AIRCREW
PROTECTIVE ARMOR

SUBJECT: Final Report - Aircrew Protective Armor

SUBJECT: Letter Report of Evaluation - Aircrew Protective Armor
(ACA 55/67I)

FIGURE 1 - FRONT VIEW

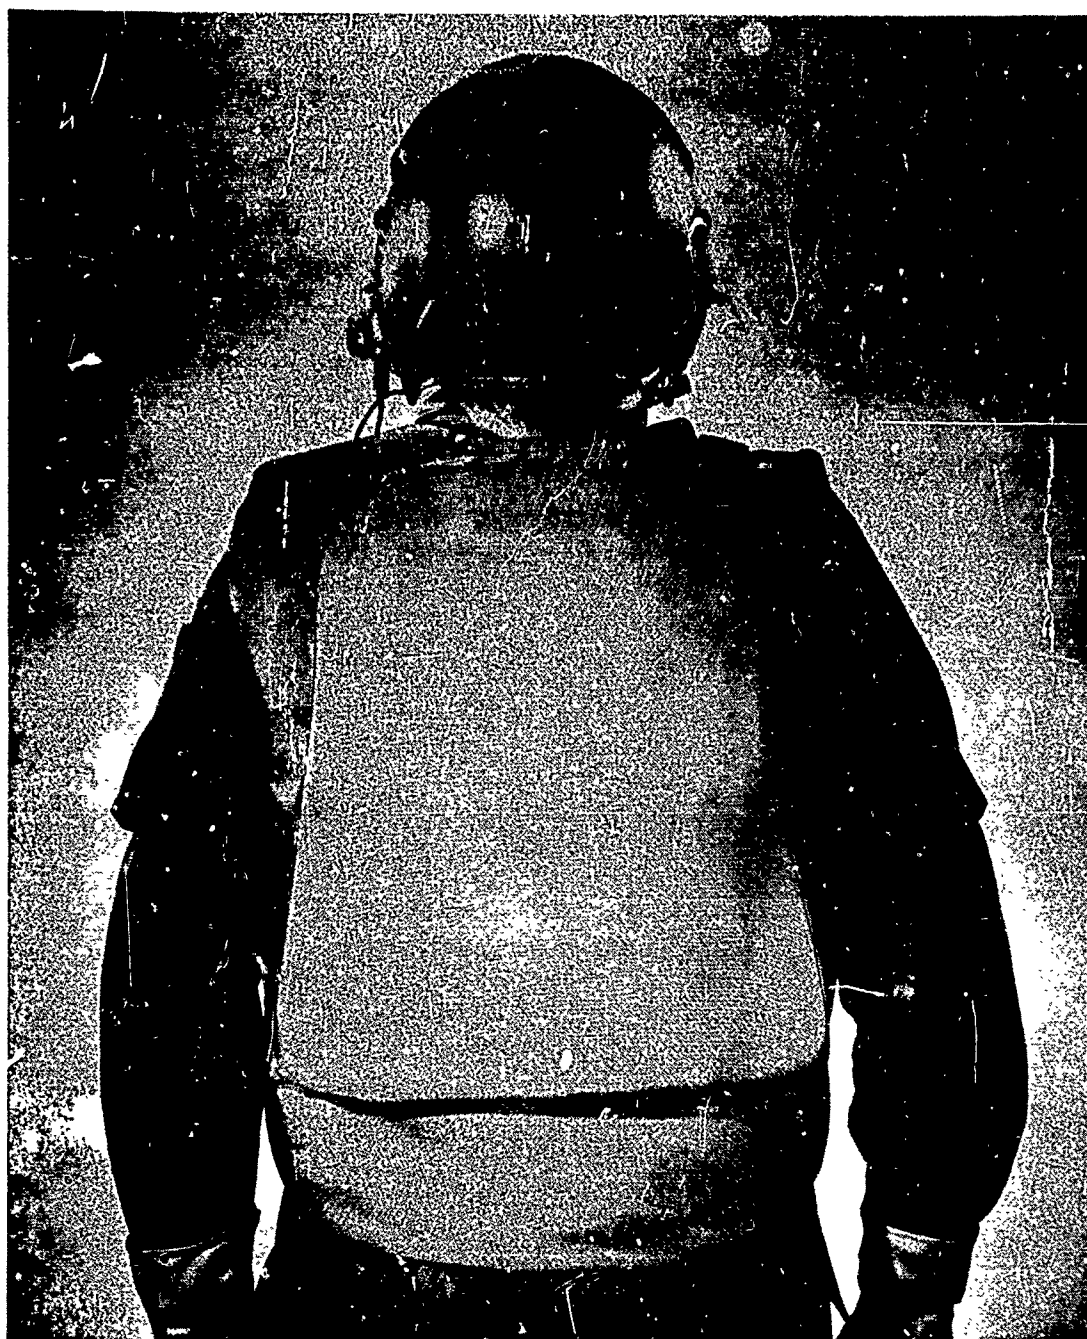
Headquarters USARV concurs with the findings, conclusions, and recommendations contained in the attached report except to clarify in para 10 a(3) that crewchief and gunner seats are not equipped with armor back rest; therefore, the fire retardant mesh back (figure 3) is not appropriate for gunner and crewchief use. The vest with back and front plates (figure 2 and 3) is required for these crewmember's protection.

(4) The collar of the new aircrew protective armor, however, hinders head movement and has a tendency to chafe the neck.

(6) The quick release on the right shoulder of the new system makes it more difficult for the pilot (right seat) to remove the vest than would a quick release on the left shoulder. To remedy this condition, a quick release could be provided on both the right and left shoulder. This release would not only increase the ease of removal of the vest in an emergency, but also would provide the aviator the option of wearing only the front portion of the vest, if desired, in flight. To permit the aviator the flexibility of wearing only the front portion of the vest, a fire-retardant mesh back portion could be provided. The mesh back could be designed to fasten to the front portion utilizing the same quick release principle now incorporated in the vest. The mesh back could incorporate the same front flap closures as the vest (Figure 1).

(2) The collar of the new aircrew protective armor hinders head movement, has a tendency to chafe the neck, and therefore should be removed.

(4) The quick release on the right shoulder of the new aircrew protective armor makes it more difficult for the pilot (right seat) to remove the vest than would a quick release on the left shoulder.

(1) Remove collar of vest

(2) Add a quick release device on the left shoulder of vest.

(3) Incorporate a fire retardant mesh back of the variable-armor design, for wear by aviators in flight (Figure 3).
